PROJECT REFERENCE NO. U-5748		SHEET NO. 10	
RW SHEET NO.			
ROADWAY DESIGN ENGINEER		HYDRAULICS ENGINEER

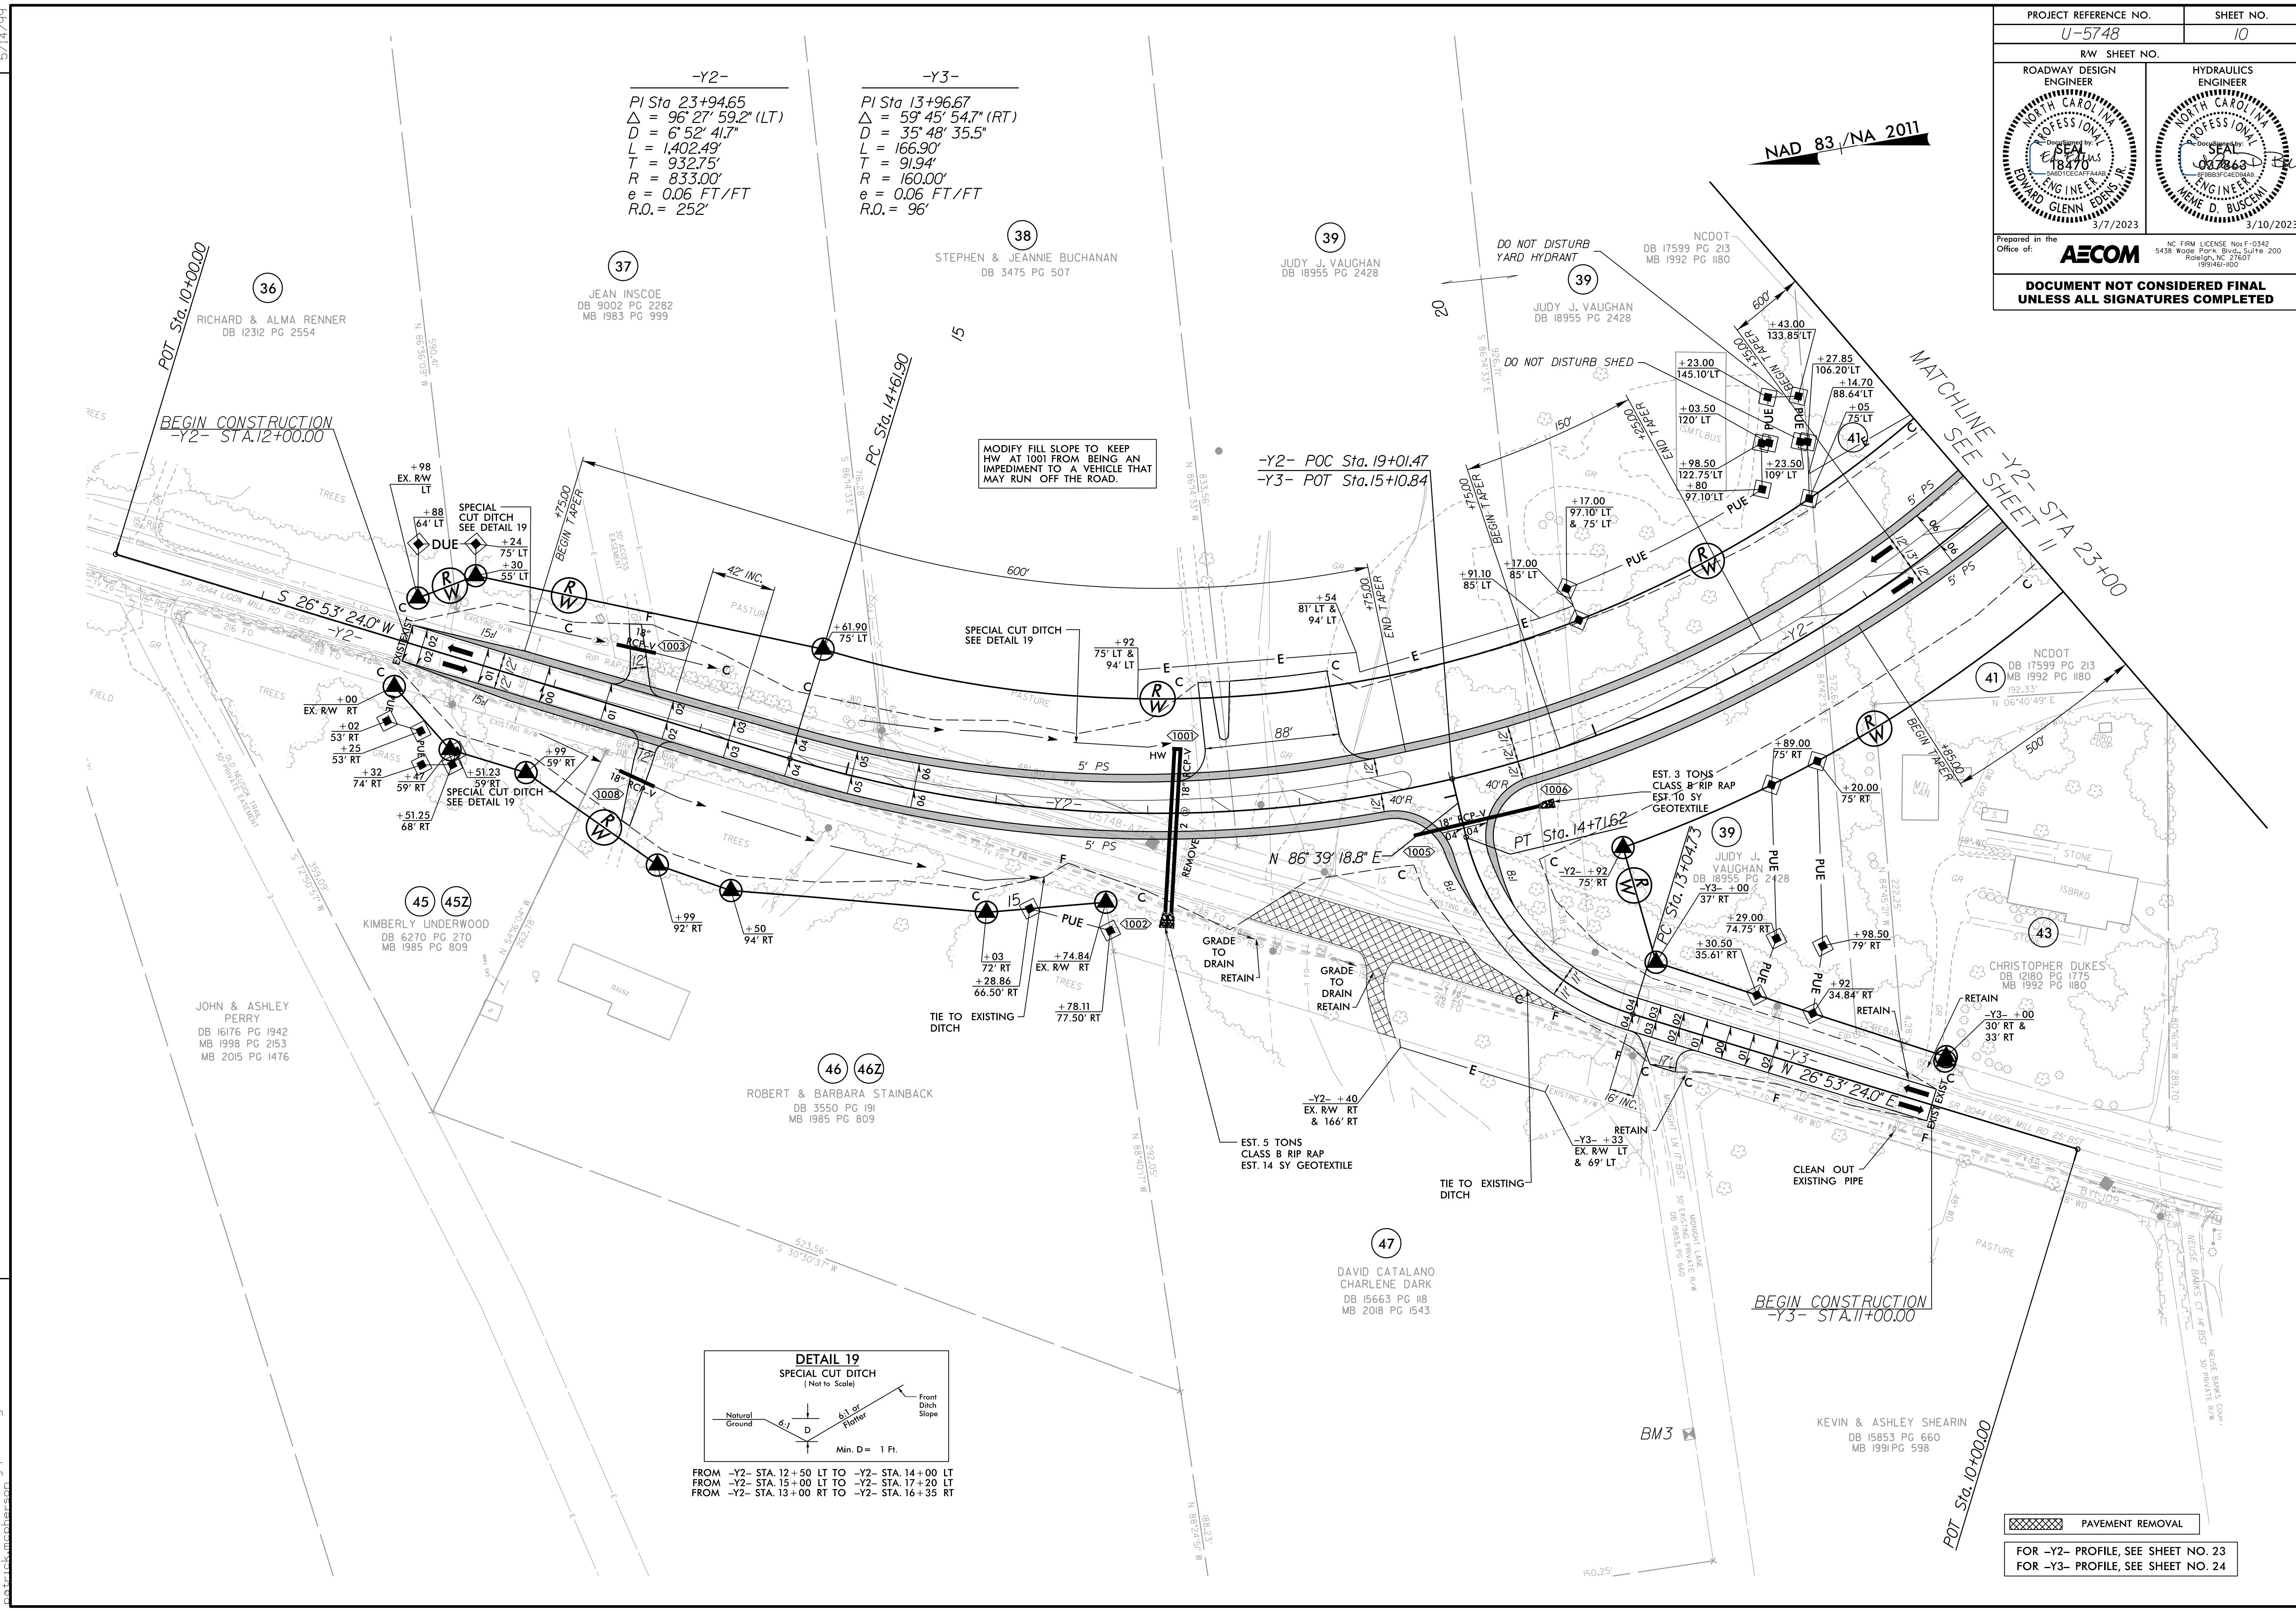
MODIFY FILL SLOPE TO KEEP HW AT 1001 FROM BEING AN IMPEDIMENT TO A VEHICLE THAT MAY RUN OFF THE ROAD.
